Access Compliance Report

Public Rights-of-Way

(Curb Ramps)

Intersection ID: 50578	Main Street: PAPER_TREE_RD	Cross Street: BENDING_BRANCH_RD	Location: W
ADA ID: 60617793D23F	Ramp Type: Perp	Initial Pass/Fail: Fail	Overall Compliance: No
Severity Score: 22.5			
Codes/Mitigation Info/Possible Solution		Field Measurements/Component Compliance

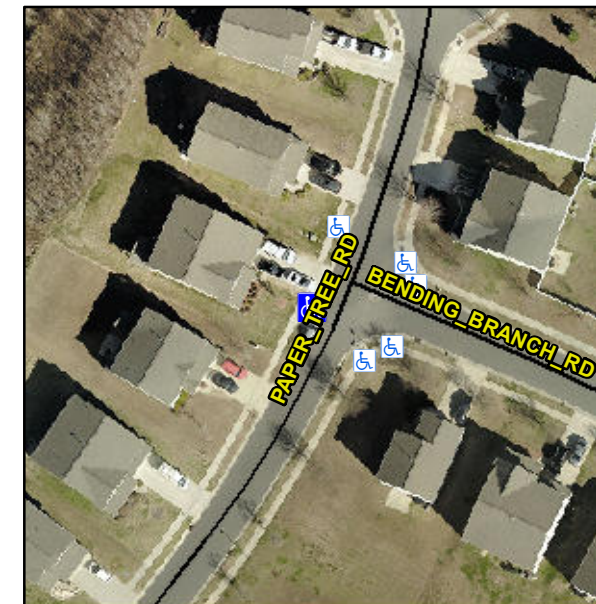
Not Found, R304.5.1, R304.2.2, R304.5.3

Compliance	Description	Data	Compliance	Description	Data
N/A	Ramp Length (in)	48.0	No	Ramp Slope (%)	10.6
No	Ramp Width (in)	47.5	No	Ramp XSlope (%)	3.1
N/A	Flare Type LT	N/A	N/A	Flare Type RT	N/A
N/A	Flare Slope LT (%)	N/A	N/A	Flare Slope RT (%)	N/A
N/A	Flare Traversable LT?	N/A	N/A	Flare Traversable RT?	N/A
N/A	Landing Length (in)	N/A	N/A	DWS Provided?	N/A
N/A	Landing Width (in)	N/A	N/A	DWS Contrast?	N/A
N/A	Landing Slope (%)	N/A	N/A	DWS Length (in)	N/A
N/A	Landing X Slope (%)	N/A	N/A	DWS Full Width?	N/A
N/A	Landing Curb? (Y/N)	N/A	N/A	DWS Offset (in)	N/A
N/A	Shared Landing?	N/A			
N/A	Gutter Ponding?	N/A	N/A	Gutter Slope (%)	N/A
N/A	Gutter Lip Ht (in)	N/A	N/A	Gutter X Slope (%)	N/A
N/A	Painted X Walk1?	No	N/A	Painted X Walk2?	N/A
	X Walk 1 Direction	To SE		X Walk 2 Direction	N/A
N/A	X Walk 1 Width (in)	N/A	N/A	X Walk 2 Width (in)	N/A
	X Walk 1 Slope (%)	4.1		X Walk 2 Slope (%)	N/A
	X Walk 1 X Slope (%)	3.0		X Walk 2 X Slope (%)	N/A

Remove & Replace Entire Ramp.
